Access Audit Site Report

Ray Roberts Lake State Park - Greenbelt Unit

Accessibility Evaluation

**TEXAS PARKS AND WILDLIFE DEPARTMENT
RAY ROBERTS LAKE STATE PARK - GREENBELT UNIT
AMERICANS WITH DISABILITIES ACT COMPLIANCE INITIATIVE
PROGRAM AND POLICY REPORT**

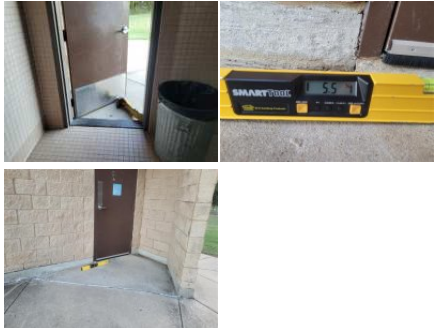
8	FM 428 Access Point: FM 428 - Picnic Area	[33.30776, -97.04086]	The fishing line disposal station and maps are positioned too high for either a side or front approach. Where a clear floor or ground space allows a parallel approach to an element and the side reach is unobstructed, the high side reach shall be 48 inches maximum and the low side reach shall be 15 inches minimum above the finish floor or ground. Where a forward reach is unobstructed, the high forward reach shall be 48 inches maximum and the low forward reach shall be 15 inches minimum above the finish floor or ground.	Fishing line disposal station and maps too high at 57"	Remount operable parts to be in reach range of 15" min to 48" max.	2015 ABAAS Section: 308.1 2012 TAS Section: 308.1 2010 ADAS Section: 308.1
